# UNITED STATES PATENT AND TRADEMARK OFFICE

APPLICATION NO.	FILING DATE	FIRST NAMED INVENTOR	ATTORNEY DOCKET NO.	CONFIRMATION NO.
10/791,084	03/02/2004	Todd W. Steigerwald	5867-00800	2937

**Office Action Summary**

## DETAILED ACTION

Figure 10

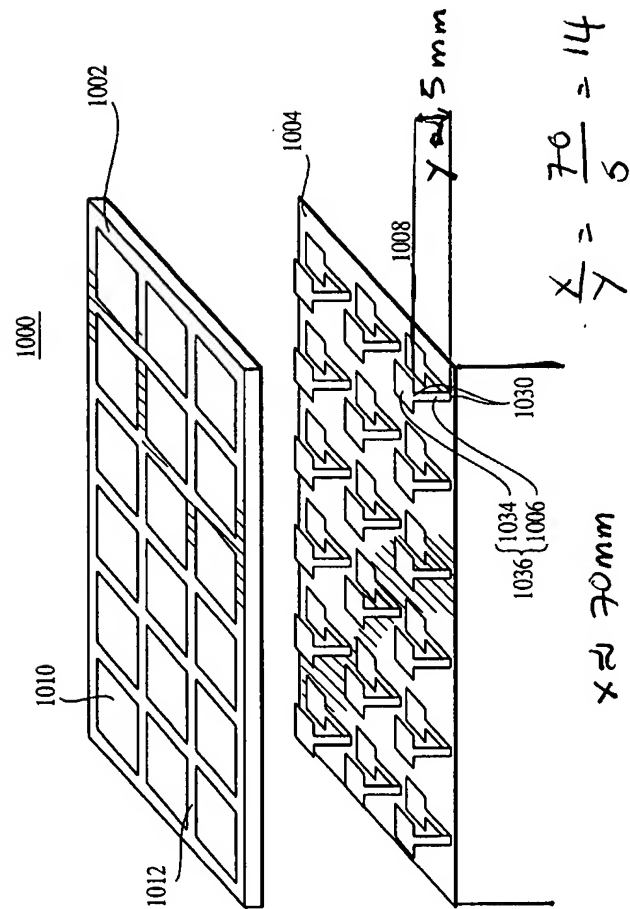
wavelength (the height of the apparatus is about  $0.005\lambda$  to  $0.05\lambda$  as disclosed in Col. 4, lines 45-47 and Fig. 10 shows the length (x) of the apparatus is about 14 times the height (y) of the apparatus (see the attachment of the annotation of Fig. 10). Therefore the length of the apparatus is about  $0.07\lambda$  to  $0.7\lambda$  that is covered the claimed value for the length of the present application). Note that each of the folded elements as shown in Fig. 2B of Lilly is as broadly as readable as a resonant circuit element as claimed by present application since it has the same configuration as Fig. 7D of application.

Regarding claim 26, Lilly discloses the plurality of resonant circuit elements having a periodic surface (1034) that is less than or equal to one-tenth of the transmitted signal wavelength (the height of the apparatus is about  $0.005\lambda$  to  $0.05\lambda$  as disclosed in Col. 4, lines 45-47 and Fig. 10 shows a periodic surface 1034 is about the same or less than the height of the apparatus).

Applicants argue that “Lily fails to teach a method for forming an apparatus in which a length of the apparatus is substantially equal to one-half of a signal transmission wavelength”. The Examiner disagrees because in Lilly, especially Fig. 10 as marked up by Examiner (see attached), includes the claimed limitation of about  $0.07\lambda$  to  $0.7\lambda$  which includes the claimed one-half of the signal transmission wavelength of the present application as claimed by the present claims.
